Plan Commission

Revised Agenda

Monday, April 30, 2018

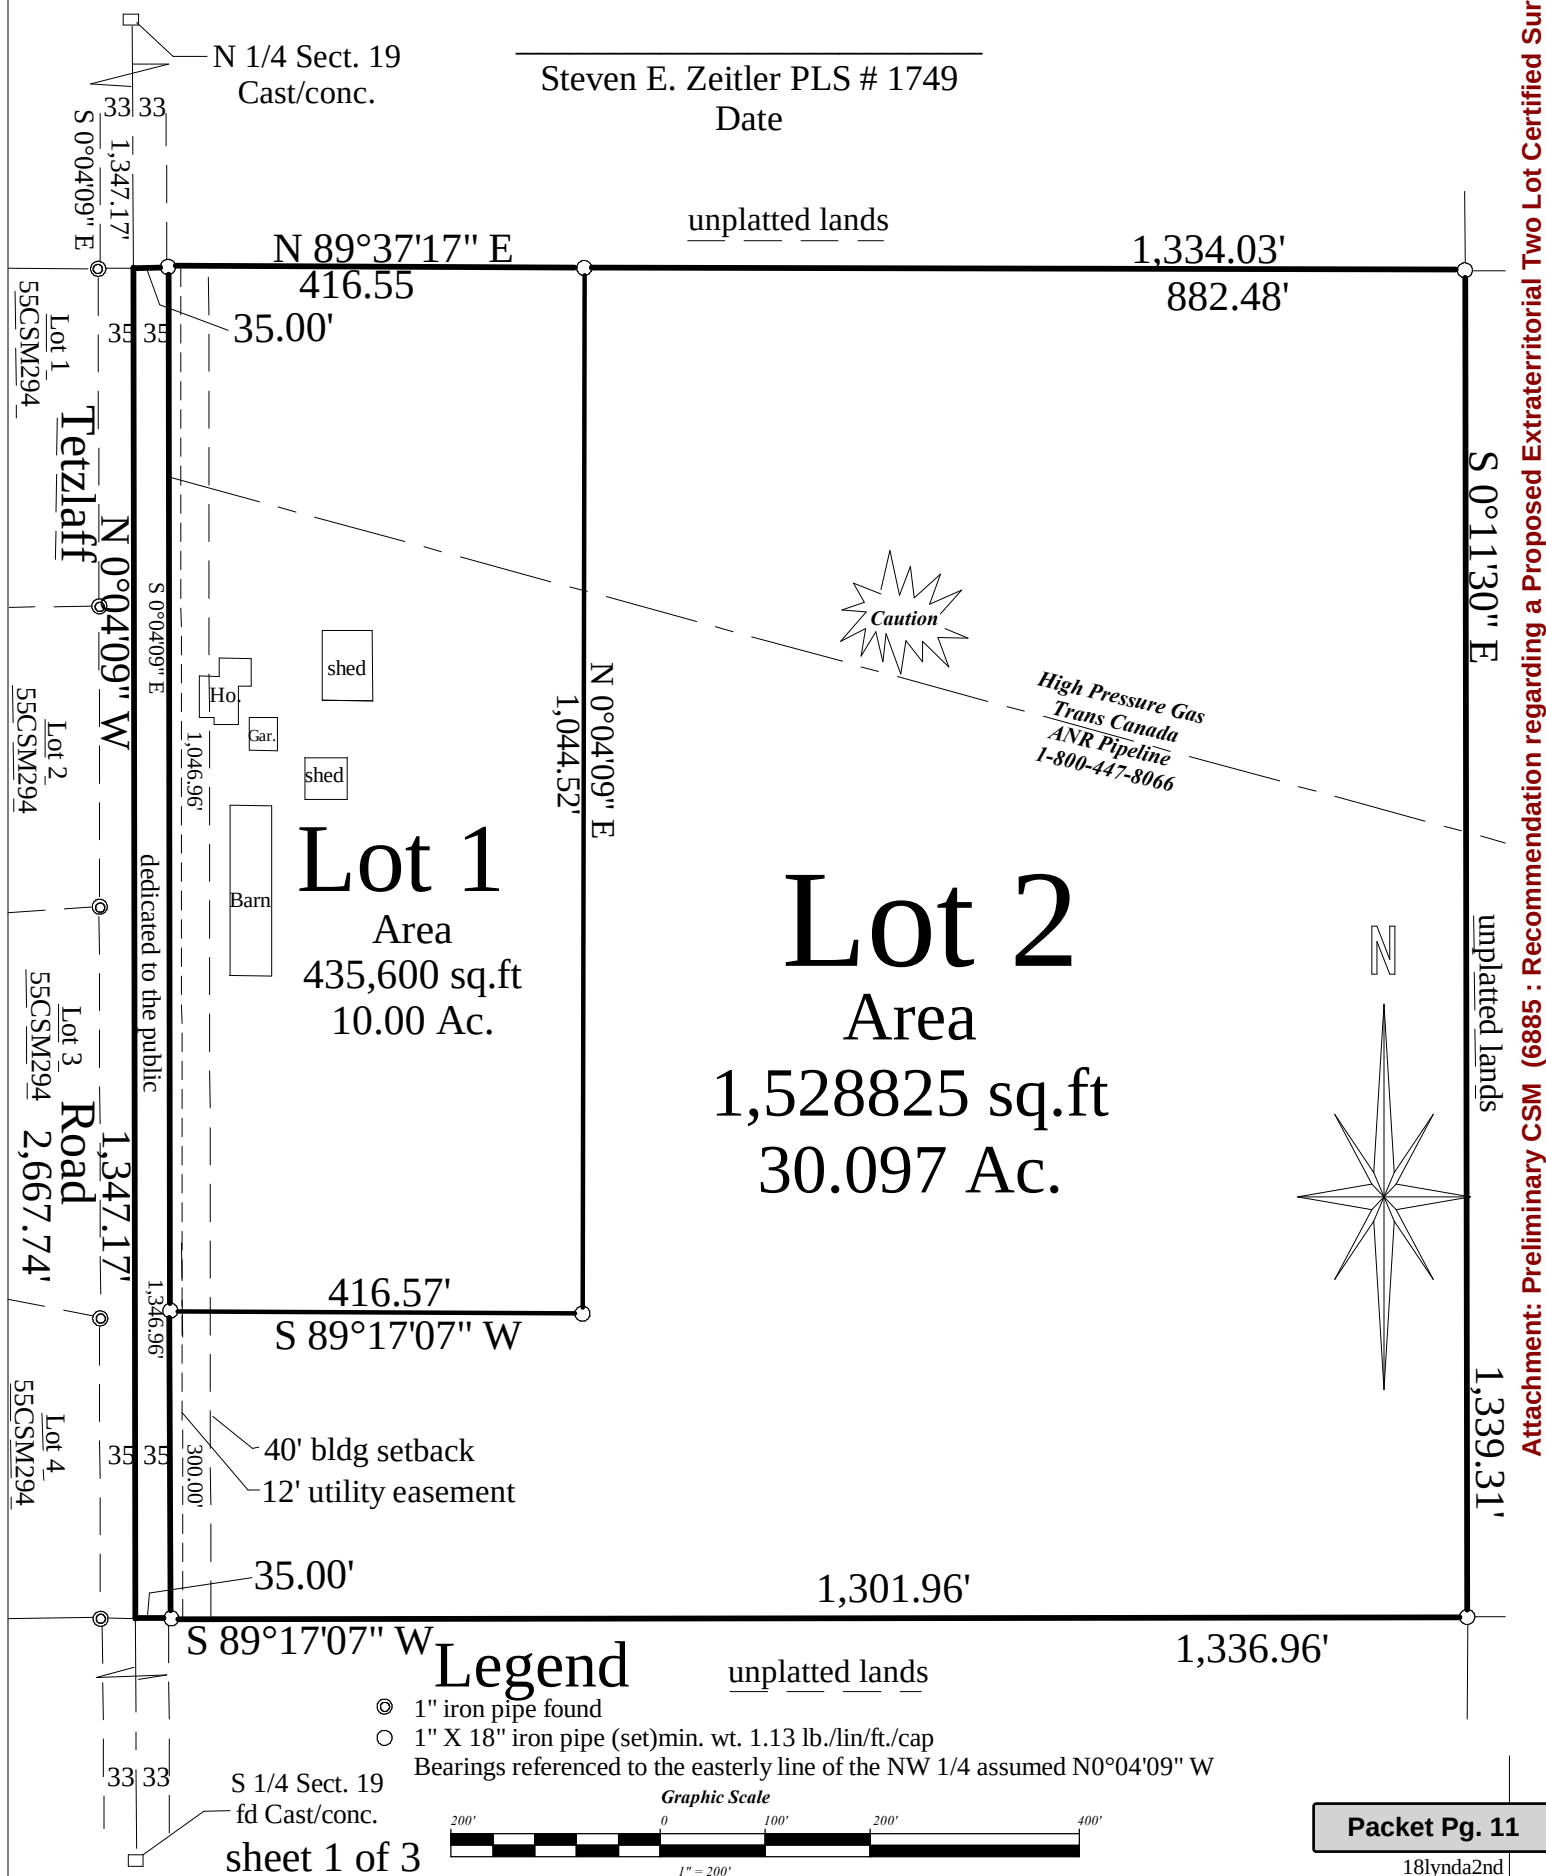
A high pressure gas Trans Canada ANR pipeline that is shown on the CSM is missing a scaled metes and bounds and pipe width measurement. The measurement details will be addressed by Brown County Planning Commission.

1. Meeting all other state and local regulations, including the Town of Rockland and Brown County Planning Commission.
2. Verify that missing metes and bounds measurements for the high pressure gas Trans Canada ANR pipeline are shown on the CSM.

Site plan with rerouted connection to Ashland Avenue shown.

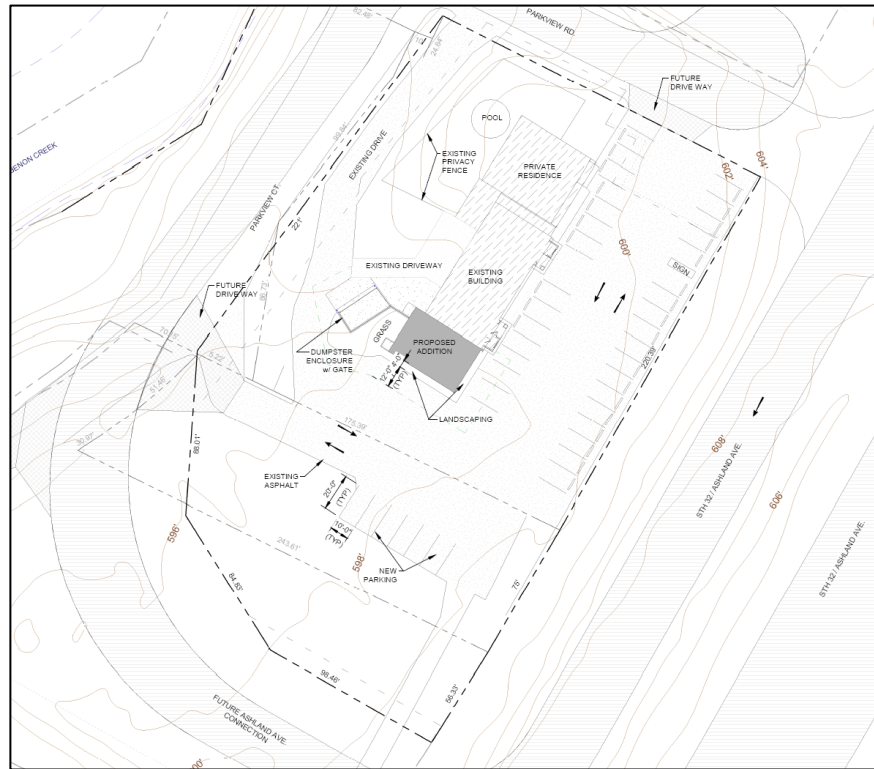
There is a shortage of 5 auto stalls. At the south end of the proposed addition there is an unused paved area that could accommodate the additional needed stalls.

1. B-2 zoned property does not allow for the use of metal on building facades; however in 2015 Plan Commission allowed the use of horizontal or vertical siding above the 3-foot stone base, which is over 26% of the wall (with glass).
2. Identify location for new business signage, if any. Please note that separate sign permits are required for new signage; the Plan Commission site plan review only acknowledges the location/existence of signs.
3. Parking Requirements per 14-56(2)(y) -- dining = 22.5 stalls, tavern = 6.5 stalls, all else = 13.6 stalls. Total 43 stalls (42.6) but the site plan shows 38 stalls. Short by 5 stalls. If parking becomes an issue, the City may order in to the construction of additional stalls on the property in order to meet Code.

Staff recommends APPROVAL of the Site Plan request for a building addition at Drift Inn, subject to compliance with the staff comments noted in this report.

West Façade with dumpster enclose at lower level.

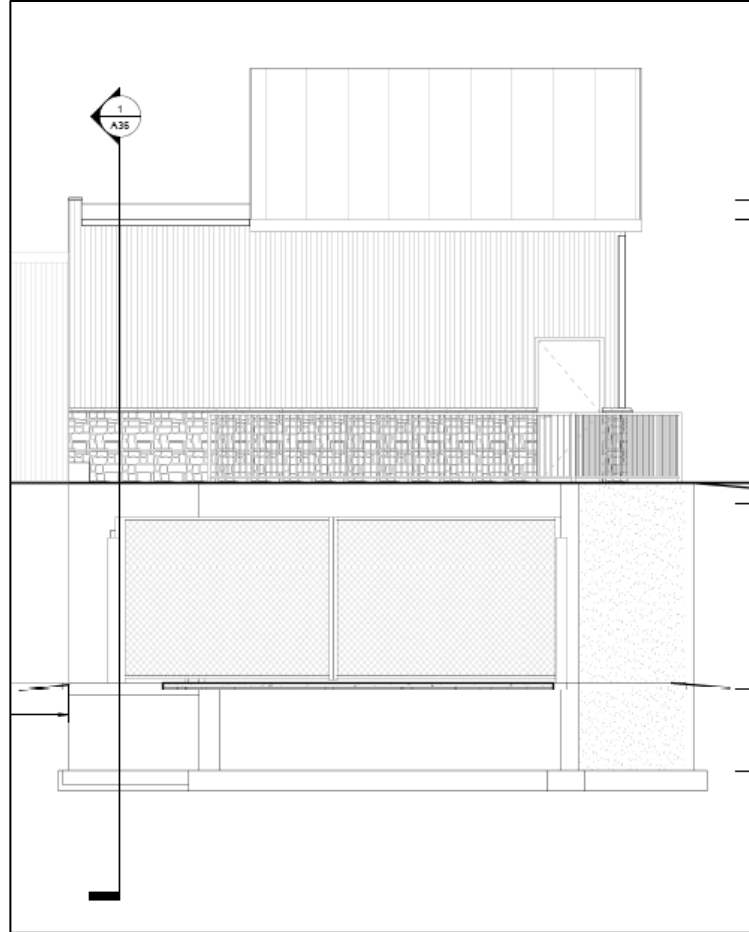
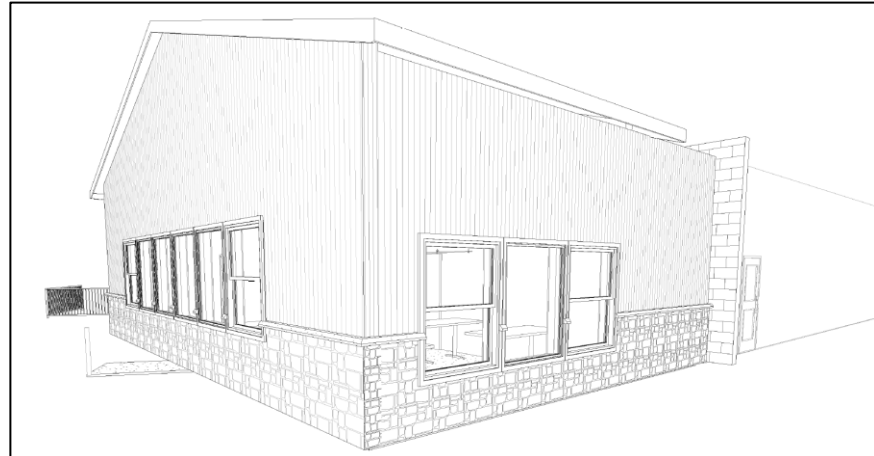
Typically mini rib (metal) is not allowed on a building in the B-2 zoning district. However, on August 24, 2015 the Plan Commission approved the use of a stone/masonry base with vertical steel masonry panels above the masonry on the original building. A similar design is being used on the proposed building addition. At the time the owner of Drift Inn was concerned that the use of high end materials on the entire façade would discourage the existing clientele from using the facility and Plan Commission agreed to the use of metal.

Site plan with proposed storm water management area and pavement.

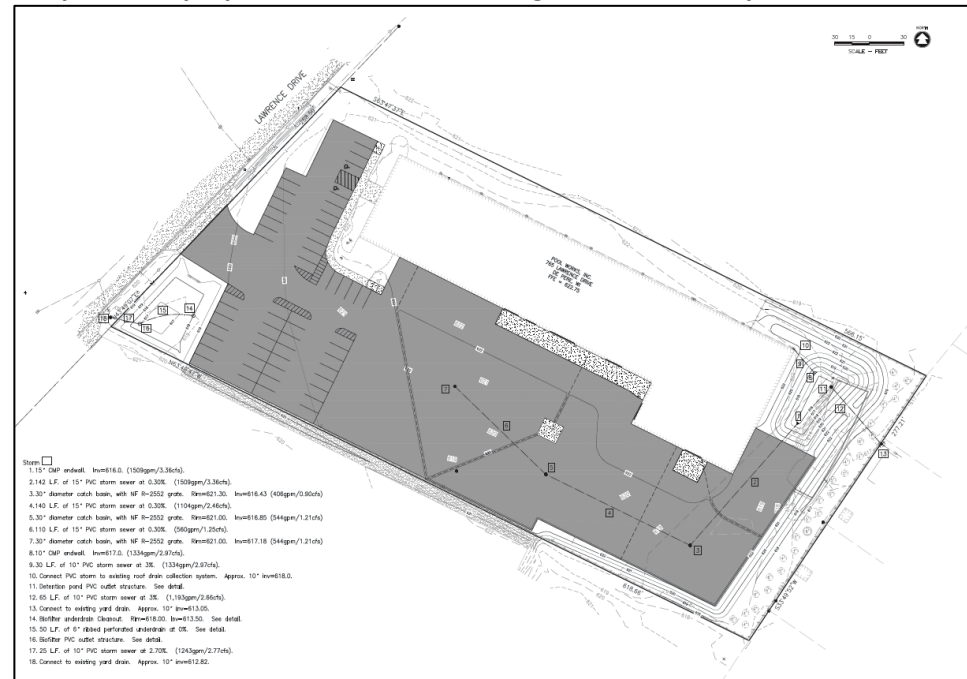
Lighting and photometric plans were not included. The lighting remains unchanged. Engineering comments include a request for information on the site plan to document that.

1. Per Municipal Code 14-60(9)(a)(2)(j): Include site statistics in the plan: site square footage, percent site coverage, percent open space, and floor area ratio. We understand this information is already in the Stormwater Management Plan.

2. Per Municipal Code 16-60(12)(k): All parking stalls shall be marked with painted lines not less than four (4) inches wide.
3. ADA 2010 Standards Chapter 2018 on Parking Space – Parking lots containing 51 to 75 parking spaces are required to provide 3 accessible parking spaces. A minimum of one of the spaces is required to be van accessible.

8. The following are required prior to obtaining an Occupancy Permit:
 - a. The City will provide a storm water maintenance agreement for the facilities.
